SUBJECT: BORON CONCENTRATION IN BORIC ACID TANKS REDUCED, SALEM NUCLEAR
GENERATING STATION, UNIT NO. 1 (TAC NO. M86723)

AMENDMENT TO FACILITY OPERATING LICENSE

Amendment No. 145
License No. DPR-70

SAFETY EVALUATION BY THE OFFICE OF NUCLEAR REACTOR REGULATION

Figure 3.1-2

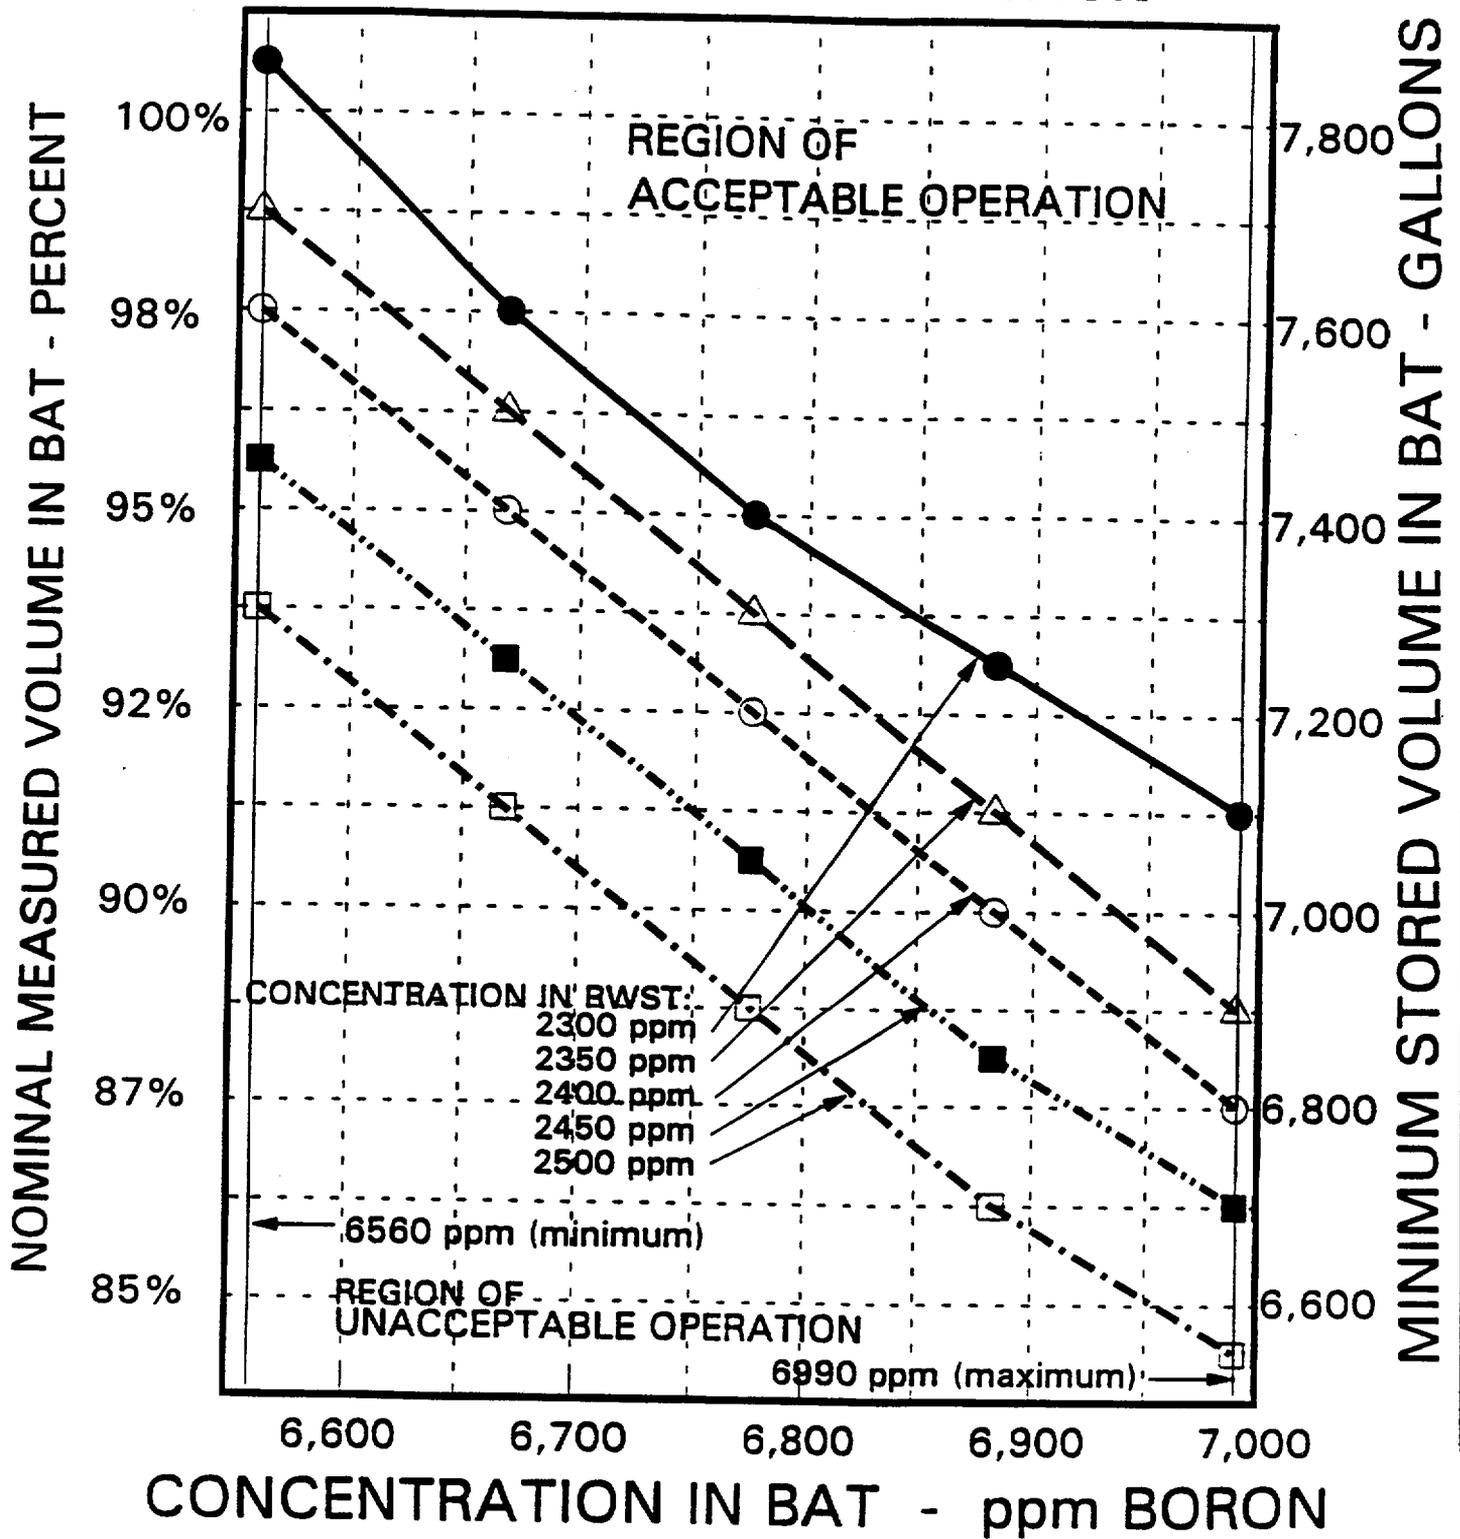
- 3.1.2.8 As a minimum the following borated water sources shall be OPERABLE as required by specification 3.1.2.2:
- a. A boric acid storage system with:
 - 1. A contained volume of borated water in accordance with figure 3.1-2,
 - 2. A boron concentration in accordance with figure 3.1-2, and
 - 3. A minimum solution temperature of 63°F.
 - b. The refueling water storage tank with:
 - 1. A contained volume of between 364,500 and 400,000 gallons of water,
 - 2. A boron concentration of between 2,300 and 2,500 ppm, and
 - 3. A minimum solution temperature of 35°F.
